Client	Persimmon Homes		
Project Title	Dappers Lane, Angmering	Project No	20079
File Reference	20079/docs/civils/planning/discon/TN01		
Prepared By	S.Marshall	Date	22 October 2021
Subject	Discharge of ADC A/76/20/PL Conditions 18, 19 and 21	Revision	-

This Technical Note has been prepared in response to an ADC (Arun District Council) Drainage Engineer request for further information/clarification¹.

Condition 17:

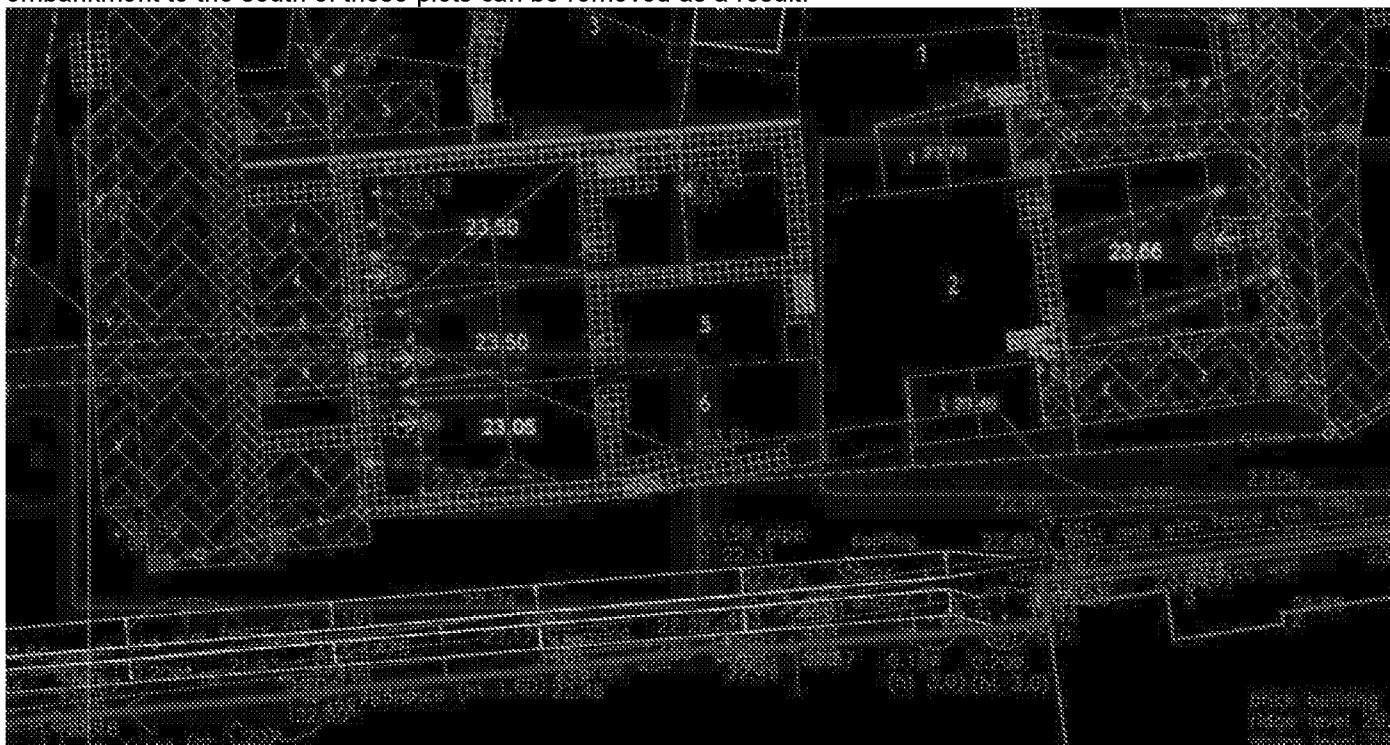
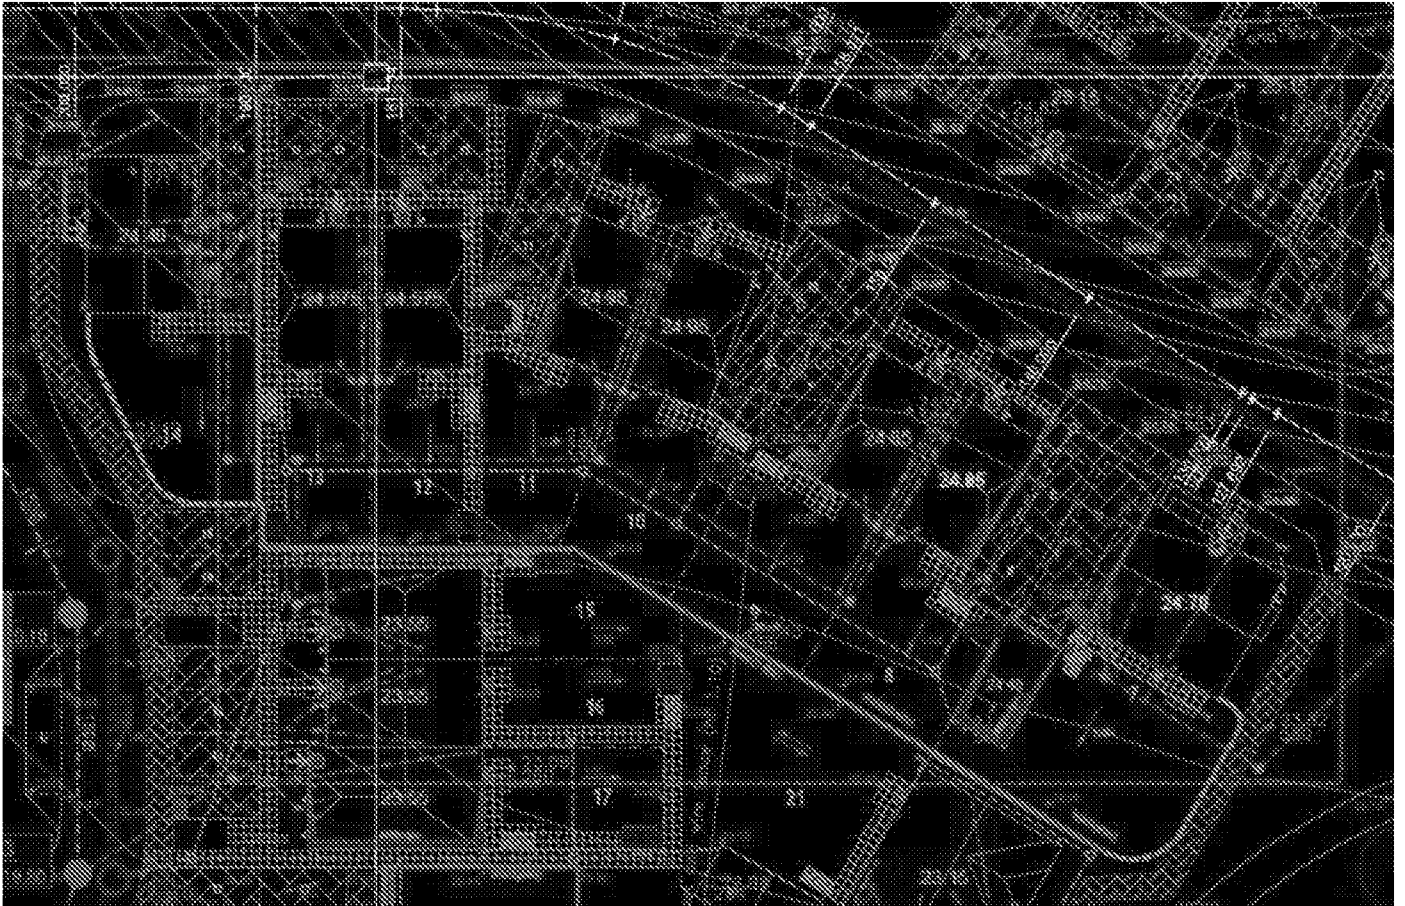
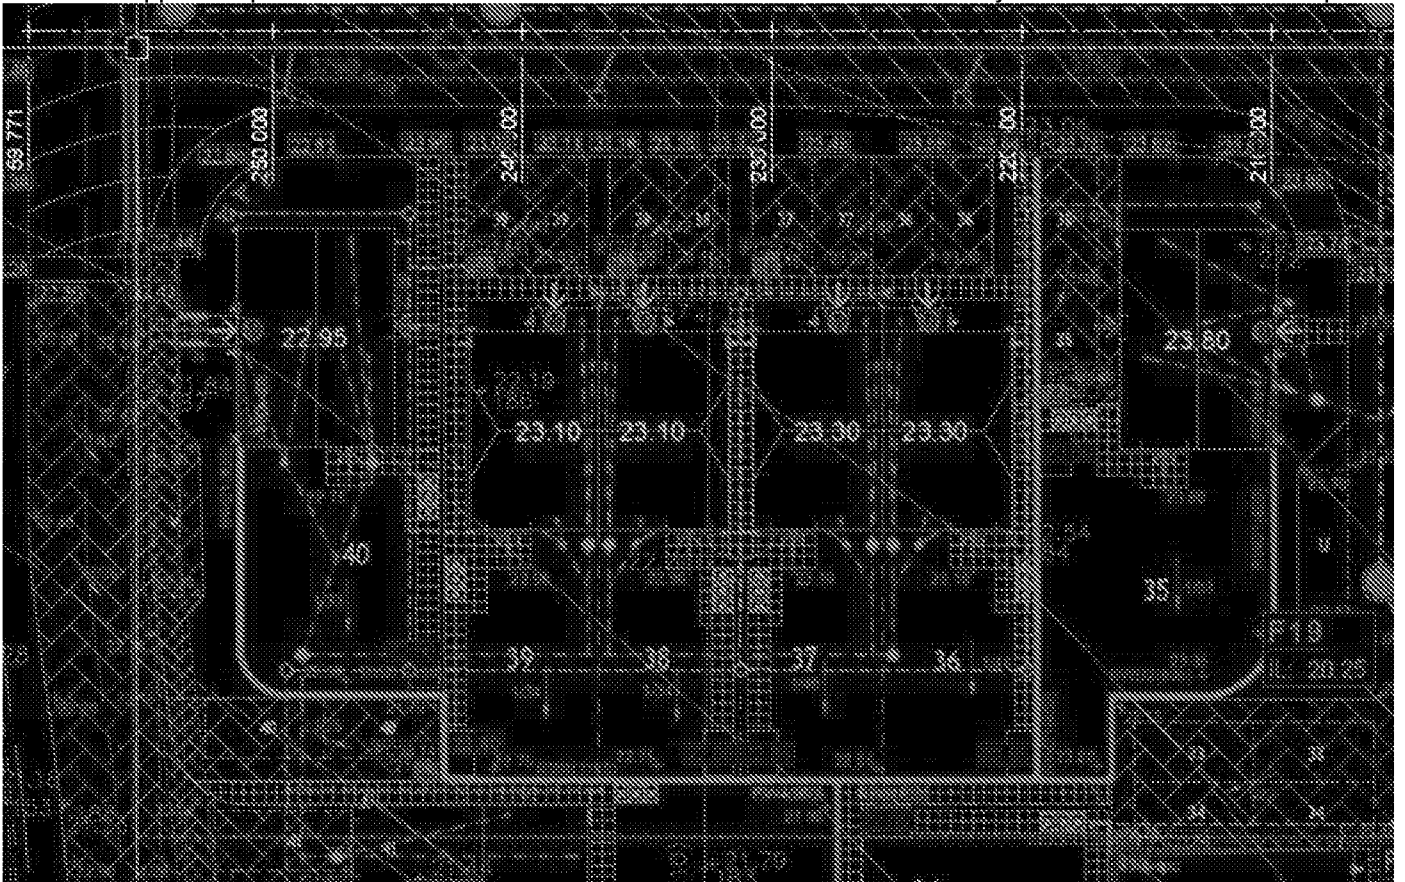
No development shall commence until plans of the site showing details of the existing and proposed ground levels, proposed finished floor levels, levels of any paths, drives, garages and parking areas and the proposed completed height of the development and any retaining walls have been submitted to, and approved in writing by, the Local Planning Authority. The details shall clearly identify the relationship of the proposed ground levels and proposed completed height with adjacent buildings. The development thereafter shall be carried out in accordance with the approved details.

We have reviewed the land raising areas of concern and have identified by relocating the cellular storage previously located to the front of plots 3-6, further west (under the LEAP area) the finished floor levels of plots 2 and 6 can be reduced (as shown below in red revision clouds) by 0.35m and 0.45m respectively. The previously proposed embankment to the south of these plots can be removed as a result.

For the remainder of the site we acknowledge that plots 7-14 (centrally located) are approximately 1m higher than existing ground levels. However, we cannot reduce the proposed levels of these plots without adversely impacting other areas of the site (due to the topography) or by introducing steps and tanking which is undesirable. We therefore propose to retain these plots at the previously proposed levels.

The same applies to plots 35-40 as these finished floor levels are also constrained by the main road back of footpath.

Condition 17:

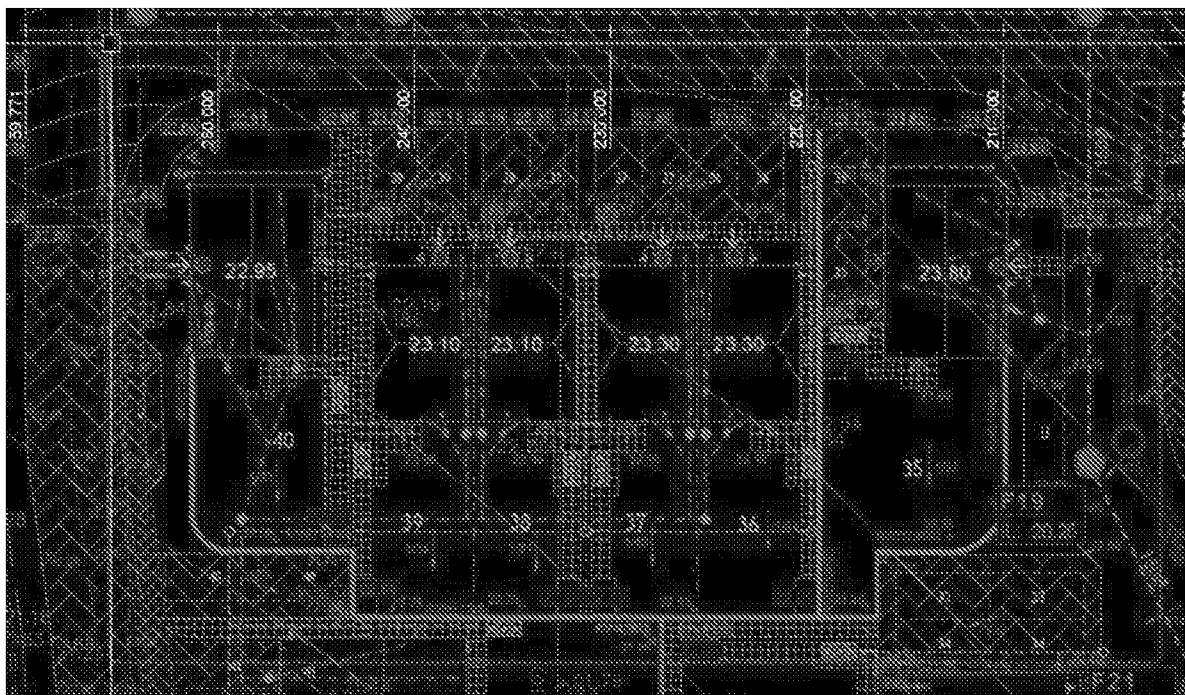
No development shall commence until plans of the site showing details of the existing and proposed ground levels, proposed finished floor levels, levels of any paths, drives, garages and parking areas and the proposed completed height of the development and any retaining walls have been submitted to, and approved in writing by, the Local Planning Authority. The details shall clearly identify the relationship of the proposed ground levels and proposed completed height with adjacent buildings. The development thereafter shall be carried out in accordance with the approved details.

- We have reviewed the land raising areas of concern and have identified by relocating the cellular storage previously located to the front of plots 3-6, further west (under the LEAP area) the finished floor levels of plots 2 and 6 can be reduced (as shown below in red revision clouds) by 0.35m and 0.45m respectively. The previously proposed embankment to the south of these plots can be removed as a result.

For the remainder of the site we acknowledge that plots 7-14 (centrally located) are approximately 1m higher than existing ground levels. However, we cannot reduce the proposed levels of these plots without adversely impacting other areas of the site (due to the topography) or by introducing steps and tanking which is undesirable. We therefore propose to retain these plots at the previously proposed levels.

The same applies to plots 35-40 as these finished floor levels are also constrained by the main road back of footpath.
